ASOS MODIFICATION NOTE 5 (for Electronics Technicians)

SUBJECT : Firmware Upgrade for Light Emitting Diode Weather Indicator (LEDWI)

PURPOSE : Update firmware on the present weather sensor microprocessor board A1A1A3

FMK #002B

SCIENTIFIC TECHNOLOGY, INC.		
2 Research Place		
Rockville, MD 20850		
Title:	CPU-A: MPU CIRCUIT BOARD	
Sheet:	Number:	Revisions:
C	STI-1103-0084	-
Date:	Drawn By:	Checked By:
08/08/91	D. A. WILLIAMS	
File:	Sheet:	of
CPU-A: MPU PCB	1	1

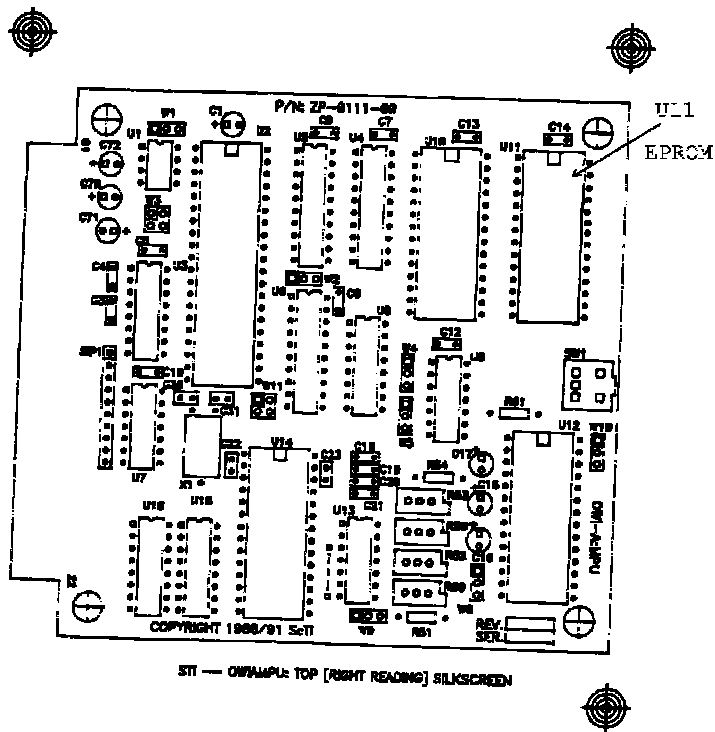
1. At the DCP, turn the LEDWI circuit breakers to 'OFF'.
2. At the LEDWI, open the electronics enclosure door.
3. Remove the MPU card located in the card cage, third slot from the top.
4. Referring to the attached assembly drawing on page 2, carefully remove the EPROM located in the U11 position.

5. Install the new Rev 3.61 EPROM in the U11 position of the MPU card.
6. Reinstall the MPU card in third slot of the card cage.
7. Close and secure the door of the electronics enclosure.
8. At the DCP, turn the LEDWI circuit breakers to 'ON'.
